Preliminary Plan Woodlawn Drive Community

PETITION NO: Z-61

ZONING COMMENTS:

Re: Application of Capital City View Homes, LLC
to Rezone a 2.15 Acre Tract from R-20 to RA-5 (No. Z-61)

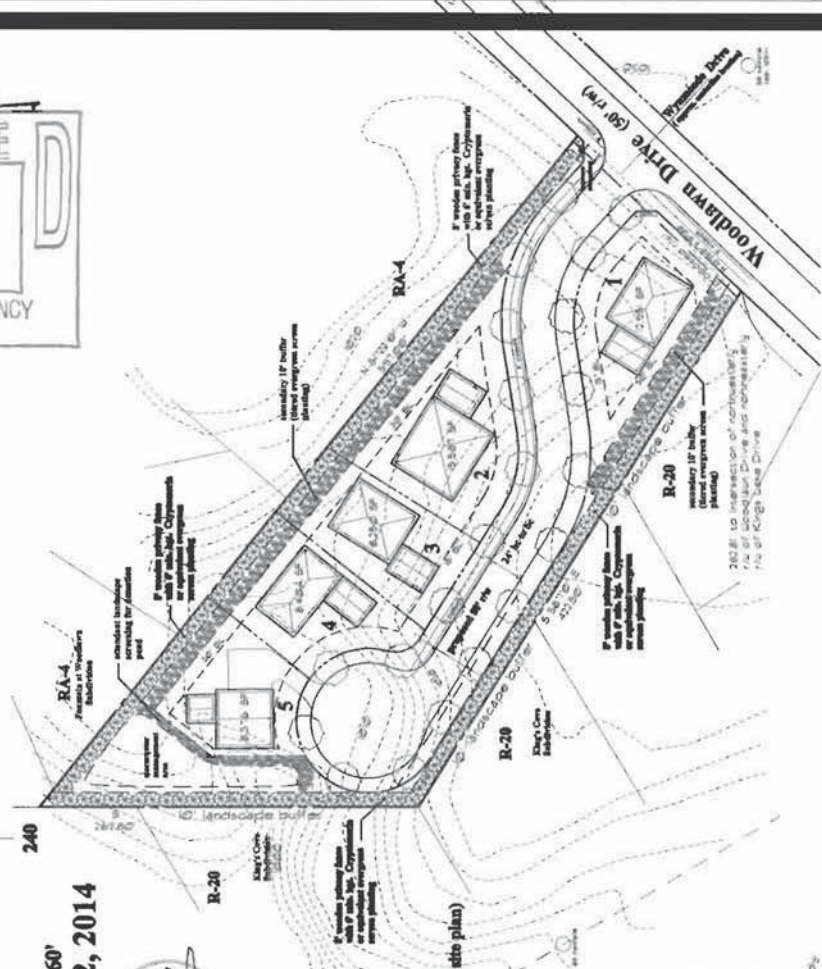
The applicant is requesting a contemporaneous variance to reduce the front setback from 20 feet to 15 feet and also to allow 30-foot rear setbacks instead of the required 40 feet as shown for Lots 2-5 and to allow the setbacks as shown for Lot 1 on the site plan received by the Zoning Division on September 23, 2014.

When projects contemplate less than 20 foot separation between units, guest parking shall be provided or the streets shall be labeled as a fire lane.

1. The entire site drains to the northwest into the Kings Cove Subdivision. However, there is no existing drainage easement to convey concentrated discharge from the site. The applicant is working with downstream property owners to obtain an easement to tie into the existing downstream storm system on Kings Lake Drive.
2. As indicated under Downstream Conditions, there is a private lake located approximately 500 feet downstream within the Kings Cove Subdivision. A pre- and post-sediment survey will be required.

Woodlawn Drive is classified as a minor collector and according to the available information the existing right-of-way does not meet the minimum requirements for this classification.

Recommend applicant consider entering into a development agreement pursuant to O.C.G.A. 36-71-13 for dedication of the following system improvements to mitigate traffic concerns: a) donation of right-of-way on the northwest side of Woodlawn Drive, a minimum of 30' from the roadway centerline.

Recommend curb and gutter along both sides and sidewalk along one side of proposed development roadway.

Recommend a taper for the Woodlawn Drive access.

Recommend applicant verify that minimum intersection sight distance is available for Woodlawn Drive access and if it is not, implement remedial measures, subject to the Department's approval, to achieve the minimum requirement of 390 feet.

Recommend development street either directly align or have an offset of a minimum of 125 feet from Wynmeade Park per Development Standard 401.10.

- Site plan received by the Zoning Division on September 23, 2014, with the District Commissioner approving minor modifications;
- Density not to exceed 2.5 units per acre;
- Fire Department comments and recommendations;
- Water and Sewer Division comments and recommendations;
- Stormwater Management Division comments and recommendations;
- Department of Transportation comments and recommendations; and
- Owner/developer to enter into a Development Agreement pursuant to O.C.G.A. §36-71-13 for dedication of system improvements to mitigate traffic concerns.
